# Access Compliance Report

## Public Rights-of-Way

Intersection ID: 10035753	Main Street: REGENCY_EXECUTIVE_PARK_DR	Cross Street: N/A	Location: N
ADA ID: 3493523DFD2B	Ramp Type: Perp	Initial Pass/Fail: Fail	Overall Compliance: No
Severity Score: 61.25			
Codes/Mitigation Info/Possible Solution		Field Measurements/Component Compliance

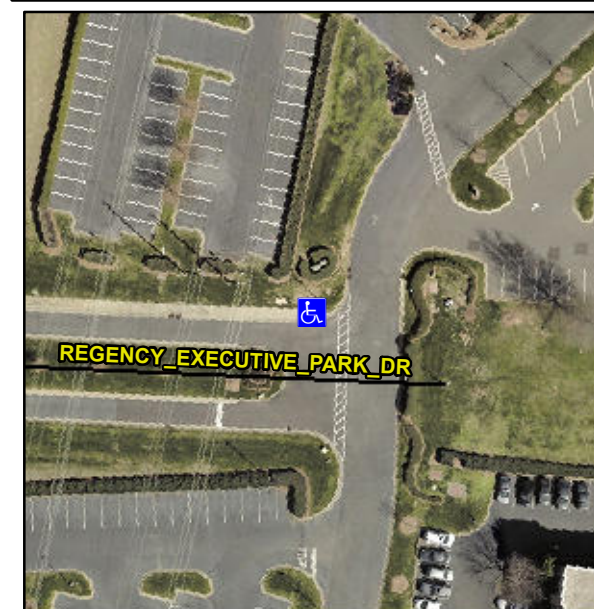
**Not Found, R304.5.1, R304.2.2, R304.5.3**

Compliance	Description	Data	Compliance	Description	Data
N/A	Ramp Length (in)	59.0	No	Ramp Slope (%)	12.8
No	Ramp Width (in)	28.0	No	Ramp XSlope (%)	3.9
N/A	Flare Type LT	N/A	N/A	Flare Type RT	N/A
N/A	Flare Slope LT (%)	N/A	N/A	Flare Slope RT (%)	N/A
N/A	Flare Traversable LT?	N/A	N/A	Flare Traversable RT?	N/A
N/A	Landing Length (in)	N/A	N/A	DWS Provided?	N/A
N/A	Landing Width (in)	N/A	N/A	DWS Contrast?	N/A
N/A	Landing Slope (%)	N/A	N/A	DWS Length (in)	N/A
N/A	Landing X Slope (%)	N/A	N/A	DWS Full Width?	N/A
N/A	Landing Curb? (Y/N)	N/A	N/A	DWS Offset (in)	N/A
N/A	Shared Landing?	N/A			
N/A	Gutter Ponding?	N/A	N/A	Gutter Slope (%)	N/A
N/A	Gutter Lip Ht (in)	N/A	N/A	Gutter X Slope (%)	N/A
N/A	Painted X Walk1?	No	N/A	Painted X Walk2?	N/A
	X Walk 1 Direction	To S		X Walk 2 Direction	N/A
N/A	X Walk 1 Width (in)	N/A	N/A	X Walk 2 Width (in)	N/A
	X Walk 1 Slope (%)	2.3		X Walk 2 Slope (%)	N/A
	X Walk 1 X Slope (%)	4.2		X Walk 2 X Slope (%)	N/A

**Remove & Replace Entire Ramp.**
